Product Change Notification - SYST-04GTSK003

ERRATA - ENC424J600/624J600 Silicon/Data Sheet Errata

ENC424J600/624J600 Silicon Errata and Data Sheet Clarification

FIGURE 1: 10BASE-T MAU EYE DIAGRAM

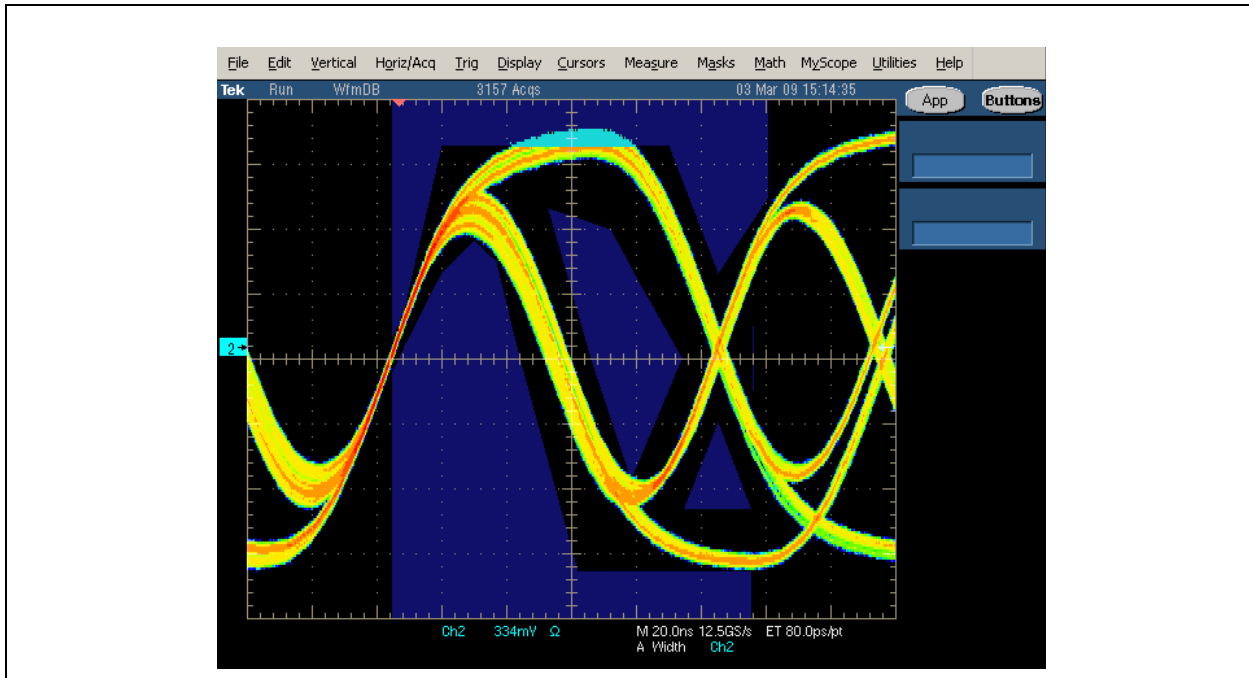
When transmitting random data in 10BASE-T mode, the PHY transmit waveform slightly violates the MAU eye diagram keep-out zones specified in the IEEE 802.3™ Std. 2005, Section 14.3.1.2.1. Specifically, the waveform amplitude is slightly too high for '0' to '1' and '1' to '0' bit transitions when tested against the twisted-pair model, as shown in [Figure 1](#).

This issue applies only to 10 Mbps speed and is unlikely to cause compatibility problems in real networks. When terminated with a 100W resistor without the twisted-pair model, the transmit waveform stays within the amplitude limits of +2.2V to +2.8V and -2.2V to -2.8V required by the standard.
